New This Issue

Revisions

Figure 1 (for Revision B4g)

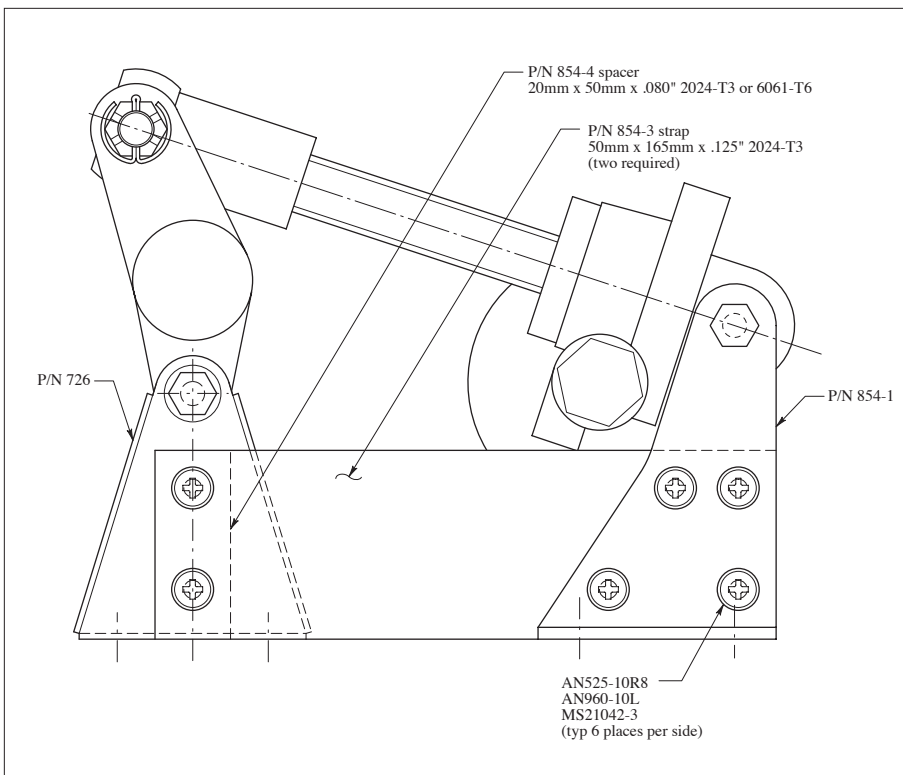
Revision B4g, June 10, 1993
 (1) Detail S. At connection of P/N 713A to P/N 743, change AN24-17 to AN174-11 and change AN320-4 to AN310-4.
 (2) Detail S. At connection of P/N 713A to P/N 709-1, change AN24-17 to AN174-11 and change AN320-4 to AN310-4.
 (3) Detail W-W. Change AN23-31 to AN173-20 and change AN320-3 to AN310-3.
 (4) Detail U. At connection of P/N 853 to P/N 854-1 & -2, change AN24-25 to AN174-17, and change AN320-4 to AN310-4.
 (5) Detail U. At installation of flap torque tube on P/N 726, change AN24-18 to AN174-12, and change AN320-4 to AN310-4.
 (6) Detail U. Show installation of braces as shown in Figure 1.

Revision G25a, December 10, 1988

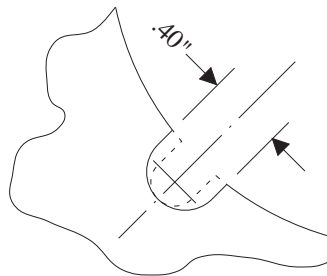
The following two changes apply to the .625"Ø hole located 167mm from the base of the part and are to accommodate new fuel selector valve:

(1) Change 21 to .58"
 (2) Change .625" to .88"
